MEMORANDUM

SUBJECT: Additional Materials
PA-18-04 Miramonte Neighborhood Plan Amendment
Study Session

Joint Statement of Neighbors for Reasonable Monastery Development and Tucson Monastery, LLC, Regarding the Benedictine Monastery Plan Amendment

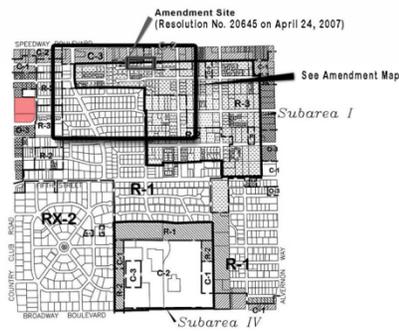
- **Height and Step-Downs:** We agreed that the 55' limit (as per UDC definition) should be the maximum allowable on site. We agreed that a step-down in the residential structure (not a garage structure) to three stories should occur along Country Club and that the east-west width of the three-story portion of the building should be no less than the depth of a single residential apartment unit. We agreed to a smaller step-down in the residential structure to mostly four stories along Anderson, corresponding to the pink area in the attached site plan. The planned garage will not have a step-down.

- **Buffers and Setbacks:** We agreed to save the oleanders at the south and east perimeter. To preserve the community's front views to the Monastery along Country Club, we agreed that we need a large building setback on the west (to the face of the Monastery Chapel), we agreed to place the parking (a minimum of single-loaded perpendicular parking) on the outer ring, which creates a large perimeter setback on the south and east. On the north, we agreed that we could minimize the setback on 2nd Street, even below the underlying zoning and with minimal setbacks adjoining the neighbor to the northeast corner of the site.
